UNITED STATES PATENT AND TRADEMARK OFFICE

APPLICATION NO.	FILING DATE	FIRST NAMED INVENTOR	ATTORNEY DOCKET NO.	CONFIRMATION NO.
10/579,956	02/20/2007	Mark Christopher Lindley	SWIN 3486	9290

Office Action Summary

DETAILED ACTION***Claim Rejections - 35 USC § 102/103***

FIG. 4

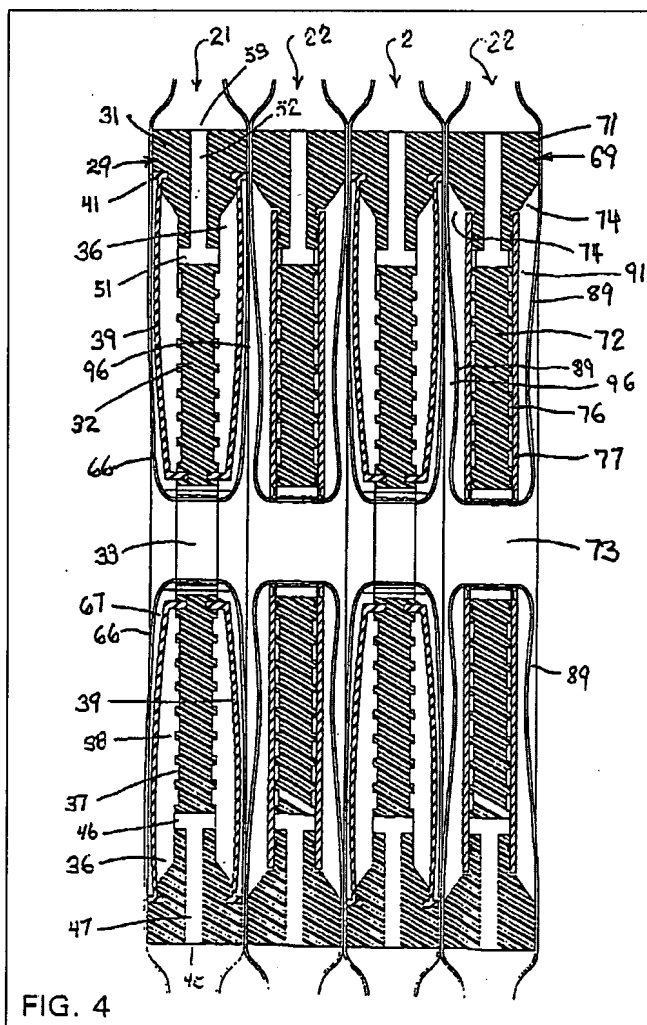
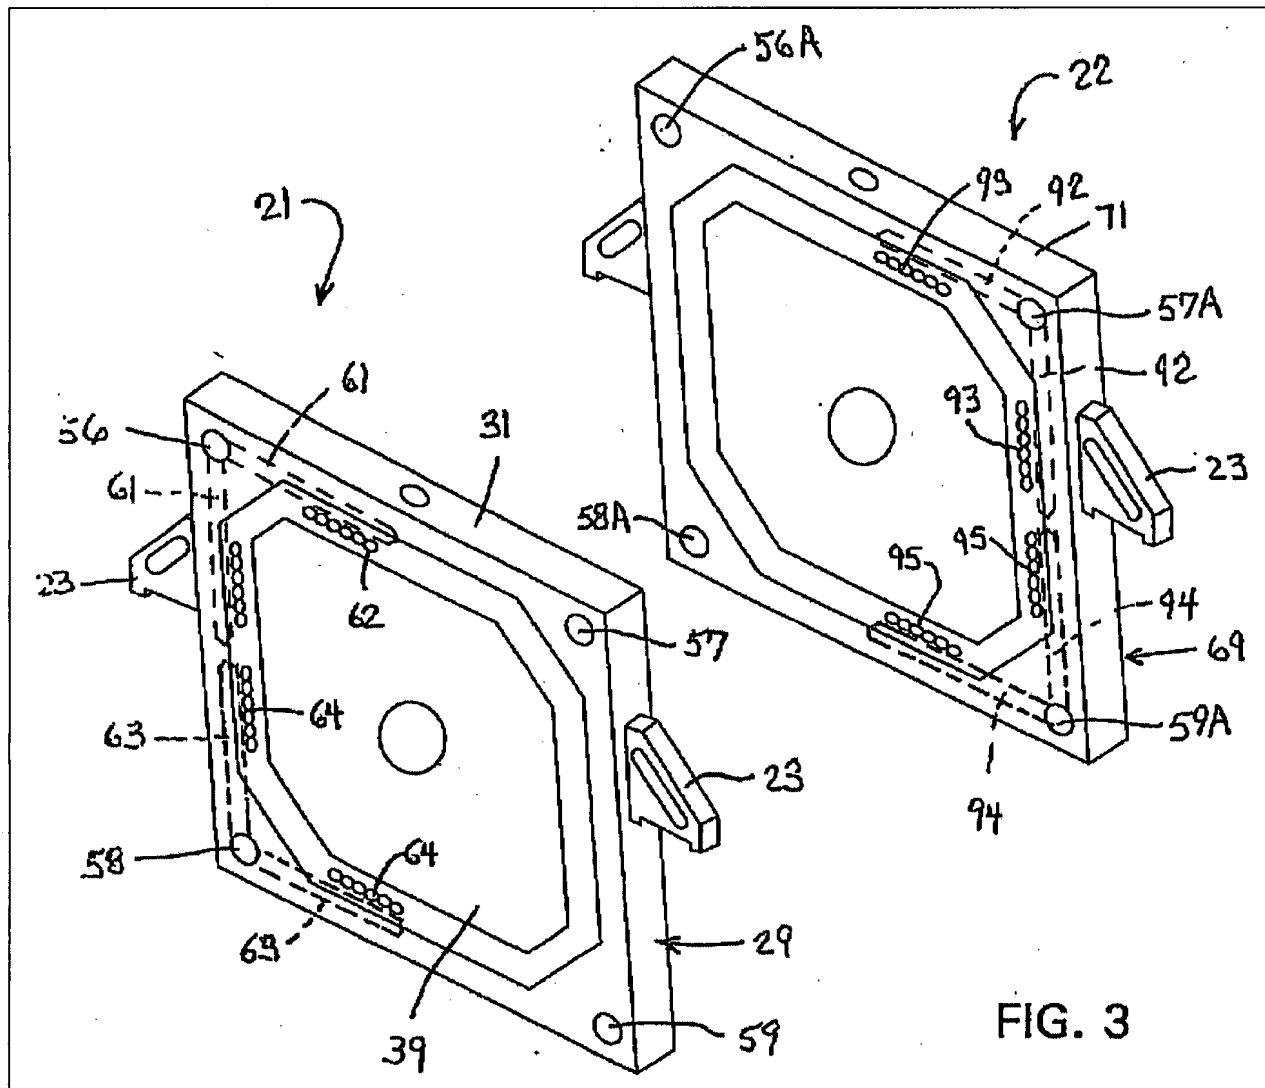
Claim 12-19 are rejected under 35 U.S.C. 102(e) as anticipated by or, in the alternative, under 35 U.S.C. 103(a) as obvious over **Hildebrandt (US 2006/0032805)**.

A filter press (11) defined by a closable stack of filter plates defined by a first plurality of membrane filter plates (21) alternately disposed with a second plurality of heating-type filter plates (22). The membrane plates (21) have chamber-defining recesses on opposite sides thereof, with each recess (36) having a flexible membrane (39) associated therewith which can be pressurized from the rearward side so as to effect squeezing of the cake in the filtration chamber. Each heating plate (22) also has chamber-defining recesses (74) on opposite sides thereof, and the main center bottom wall (76) of each recess (74) has a metal heat transfer surface (77) associated therewith, the rear side of which is in intimate contact with a chamber or passage (79) which receives therein a high-temperature heat transfer fluid.
